Change List

TX MODULE

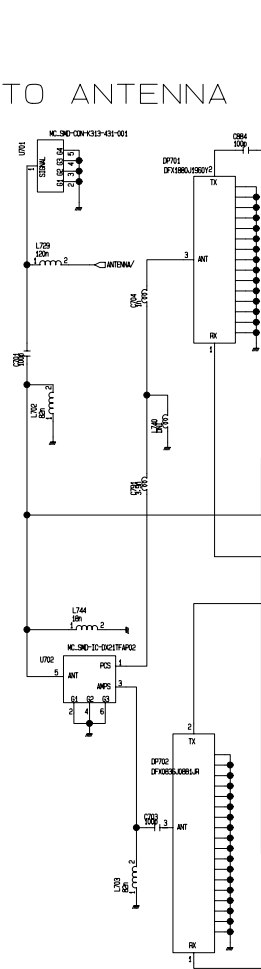
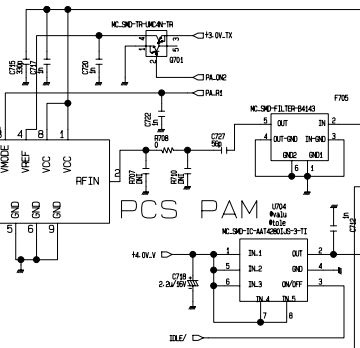
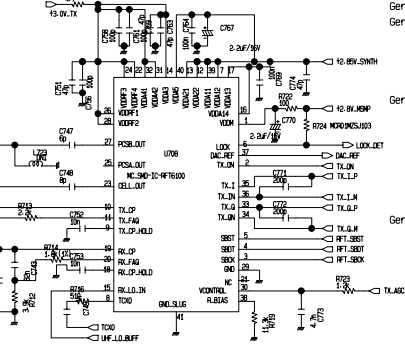
- Gen7.1L
- Gen7.1L-Rev. A ('06.01.05)
 - 1) DCN Duplexer
 - 2) 3W -> 0.6W
- Gen7.1L-Rev. B ('06.02.16)
 - 1) PAM change (DCN-PCS)
 - DCN = AW16301R
 - PCS = AW16302R
 - 2) L742- L742 : removed
 - 3) C729 : DNI ('005)
- Gen7.1L-Rev. D ('06.07.04)
 - 1) U712 LMV225 revised

LDOs & RESET PART

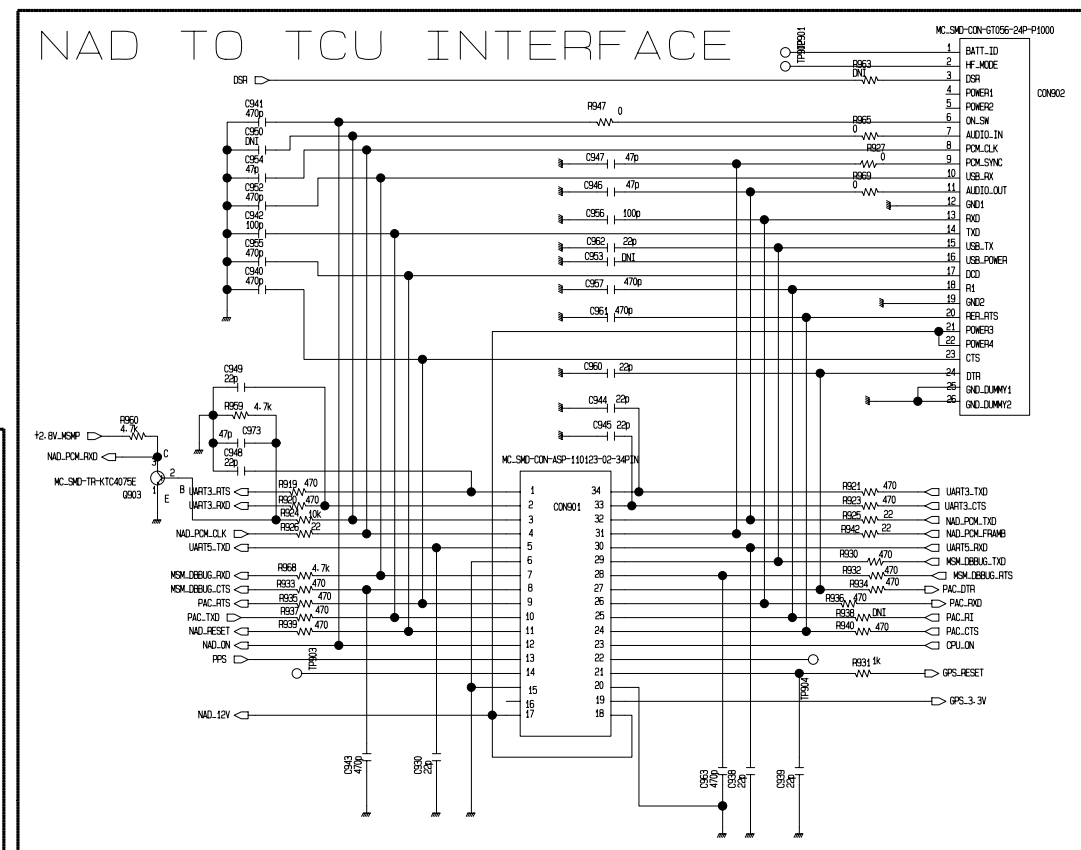
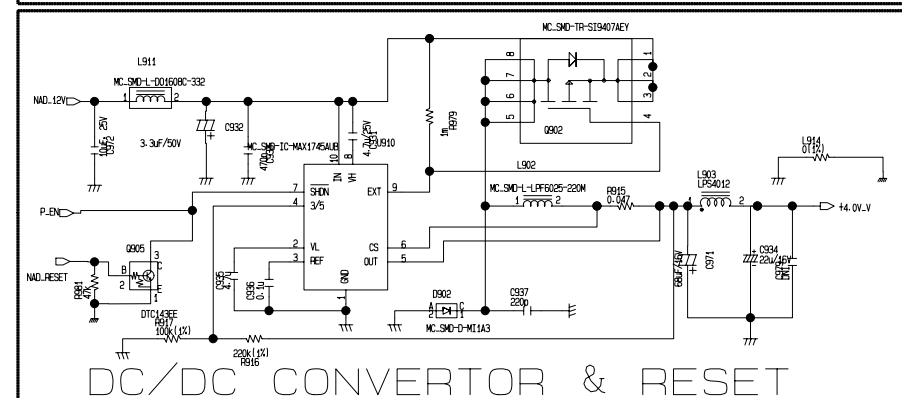
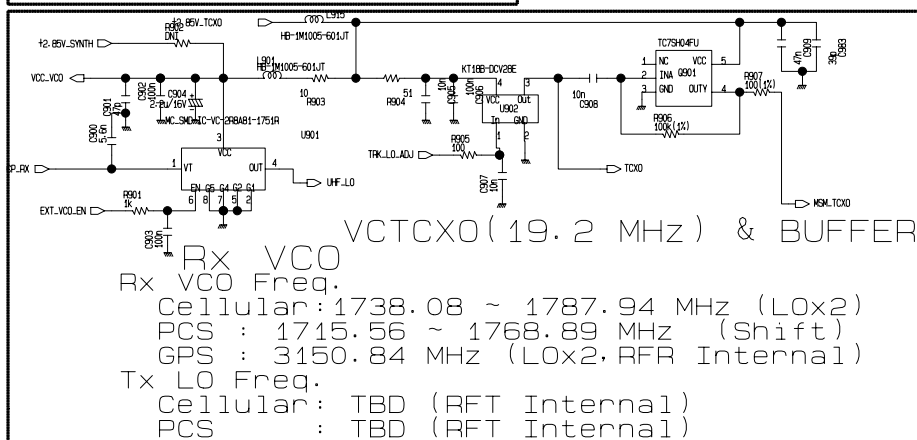
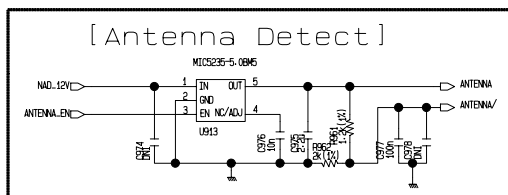
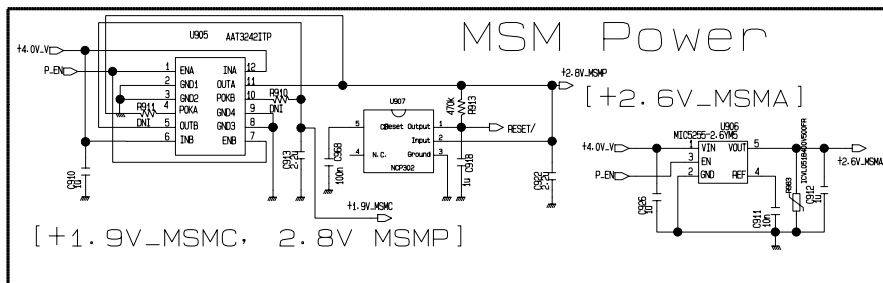
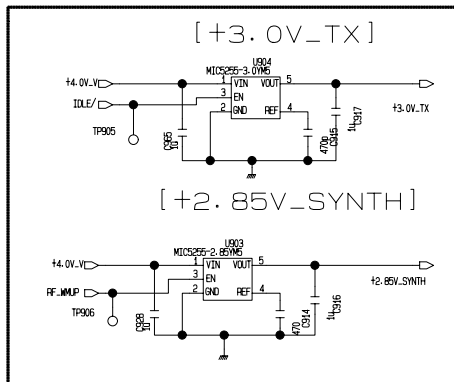
Gen7. 1L
Gen7. 1L_Rev. A (' 06.01.05)

1) Gen7.0L apply
NAD_RESET
NAD PCM Part

Gen7. 1L_Rev. C (' 06.06.03)

1) R982 added

Gen7. 1L_Rev. D (' 06.07.04)

1) RESET IC added (U907)
2) C967, C968 added

Gen7. 1L_Rev. 1. 1 (' 06. 08. 18)

1) RC filter & RESET IC

GPS BLOCK

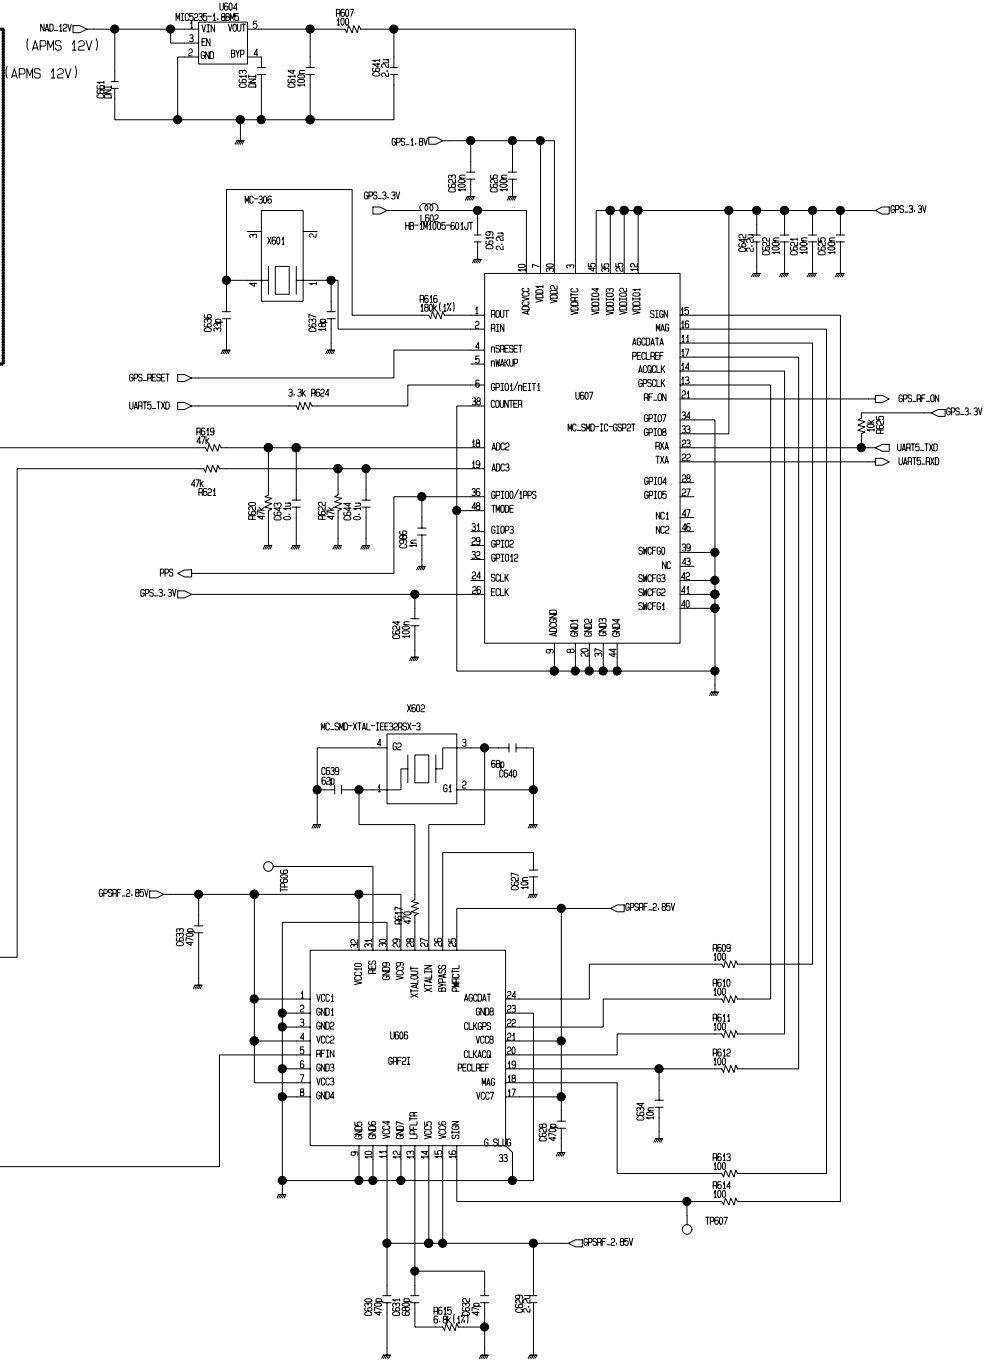
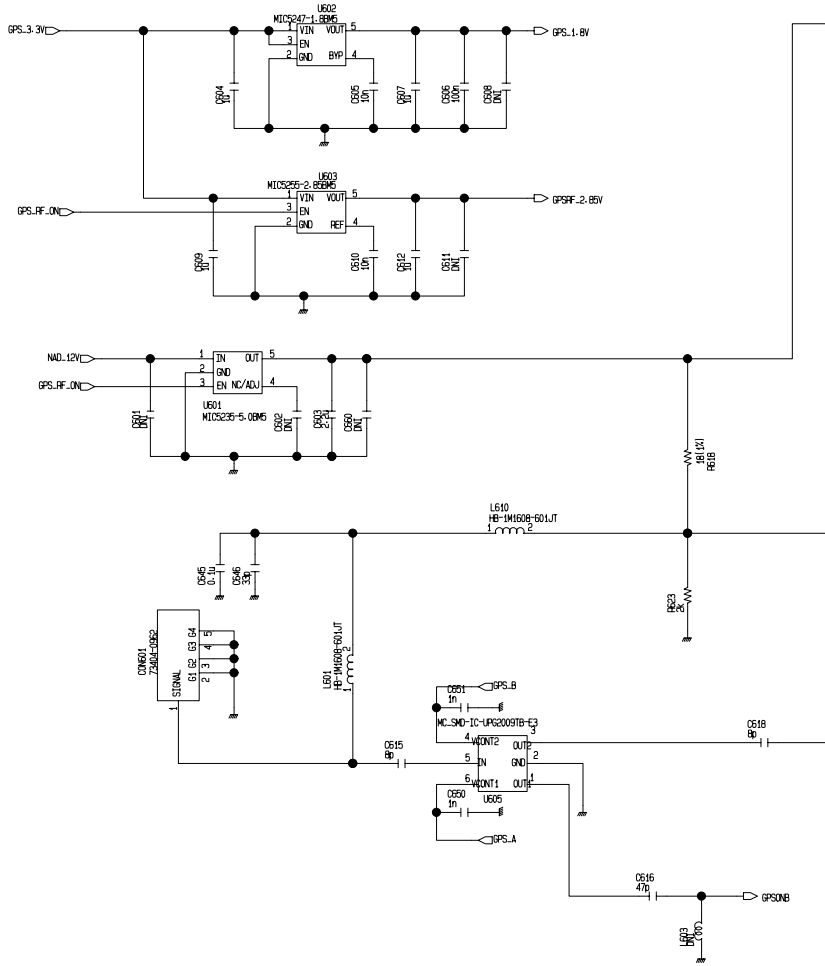
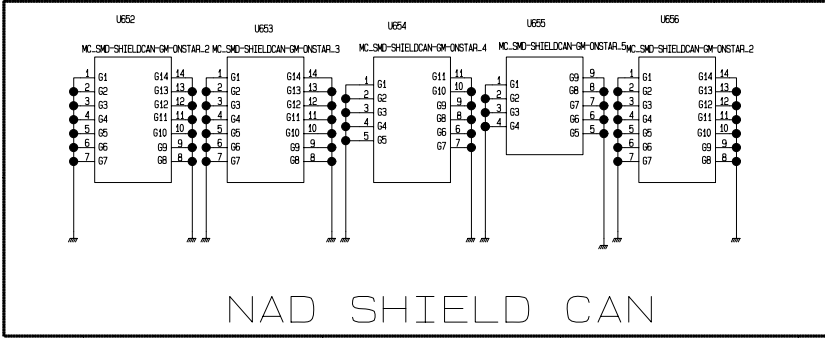
Gen7. 1L
Gen7. 1L_Rev. A ('06.01.05)

Gen7. 1L_Rev.D (' 06.07.04)

- 1) C613 change location
- 2) R624 : 3.3k included
- 3) L602 included

Gen7. 1L_Rev. 1.0 (' 06.07.18)

- 1) C613 = DNI
- 2) R625 = 10k included
- 3) R618 = 18 (%) changed
- 4) C619 = 2.2u
- 5) C614, C641: location changed
- 6) C602, C613 = DNI
- 7) R602 removed
- 8) C601, C661: DNI (2012)
- 9) C614 = 100n (100S) changed
